REQUEST FOR INFORMATION **DATE:** March 10, 2017 **NO.:** RFI-478

Project Name: 15051-Webster University Interdisciplinary Science Building Project No.: 15051

Subject: Dimensions for directory inset at elevator entrance

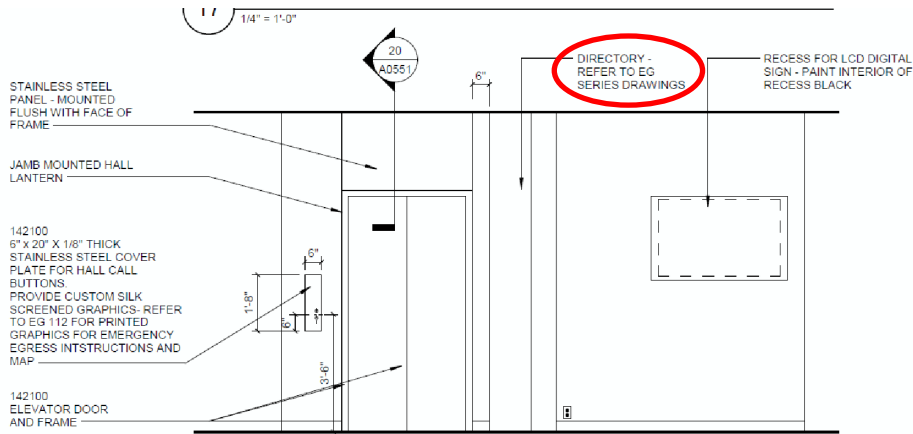
16/A0551 states to refer to the EG drawings for the inset shown for the directory at the elevator. EG111 shows a 24" wide panel with oak veneer mounted to 3/16" mdf backer then mounted to an aluminum metal plate for rigidity. The signage is no longer in Paric's scope so we intend to inset this area 3/4" and the signage can be shimmed out as needed when Webster's signage contractor installs.

Suggestion: Please confirm this will be acceptable.

As discussed with Jason, provided recess to accommodate following installation
- 3/4" particleboard mounted with z-clips (3/8" thick).
Face of particleboard to be flush with face of adjacent wall.
